Subject: Safety Recall BLC (Interim B2C) - **Interim Notice**
Certain 2004 - Early 2007 Model Year RX 330, RX 350 and RX 400h Vehicles
Driver's Side Floor Carpet Cover and Retention Clip

**Certain 2004 – 2007 Model Year RX330/350/400h
Floor Carpet Cover and Retention Clip
Safety Recall Notice (*Interim Notice*)**

Safety Recall BLC - Q&A
Certain 2004 - Early 2007 Model Year RX 330/350/400h
Driver's Side Floor Carpet Cover and Retention Clips

Safety Recall BLC (INTERM B2C) – INTERIM Carpet Floor Cover and Retention Clip Inspection 2004 through Certain Early 2007 Model Year RX330/RX350/RX400h

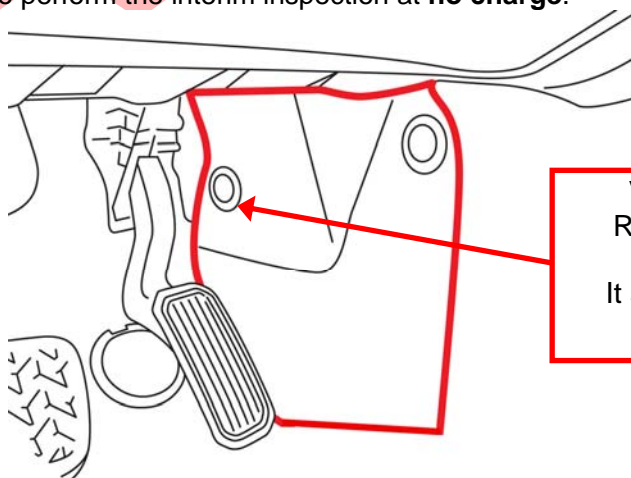
In certain 2004 through 2007 model year RX330/350/400h vehicles, if the forward retention clip used to secure the driver's side Floor Carpet Cover, which is located in front of the center console, is not installed properly, the cover may lean toward the accelerator pedal and interfere with the accelerator pedal arm. If this occurs, the accelerator pedal may temporarily become stuck in a partially depressed position rather than return to the idle position. An accelerator pedal temporarily stuck in a partially depressed position may increase the risk of a crash.

Verify that the Forward Retention Clip is properly installed. It should not be missing or loose.

Once the remedy parts are available, Lexus will replace the Floor Carpet Cover with one of a different shape as well as the forward and rear retention clips. ***Lexus will send a second owner notification letter when the replacement parts are ready and preparations are complete.***
